Informal Document No. 16

Working Party on General Safety Provisions (GRSG)
(Eighty-second session, 29 April - 3 May 2002,
agenda item 2.)

PROPOSAL FOR A REVISION TO REGULATION No. 36
(single-deck large passenger vehicles)

Transmitted by the Expert from the United Kingdom

Figure 13

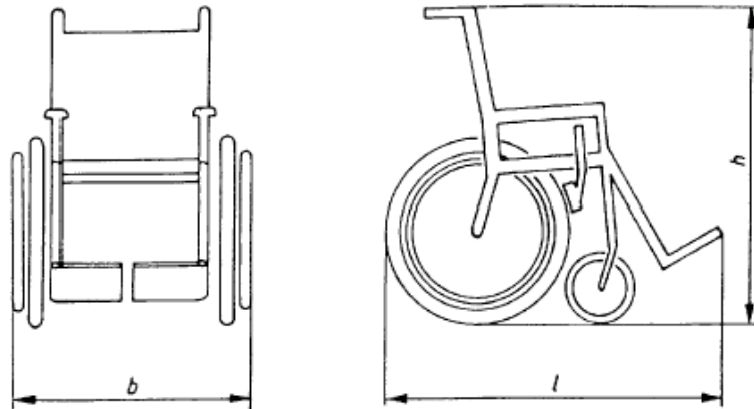
Overall length, l: 120 cm
Overall width, b: 70 cm
Overall height, h: 109 cm

A wheelchair user seated in the wheelchair adds 5 cm to the overall length and makes a height of 135 cm above the ground.

area(s) with a reference wheelchair of the dimensions shown in Annex 3, figure 13.

Figure 14

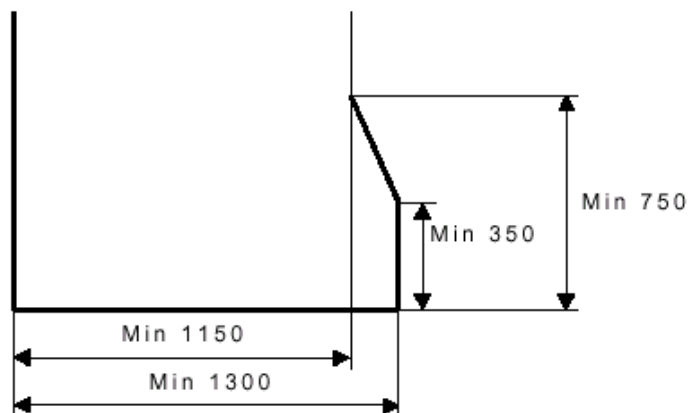
Minimum clear space for the wheelchair user at the wheelchair space

(Note: Diagram as shown above but with units in cm)

In the case of a wheelchair space designed for a forward facing wheelchair, the top of preceding seat-backs may intrude into the wheelchair space if a clear space is provided as shown in Annex 3, figure 14.
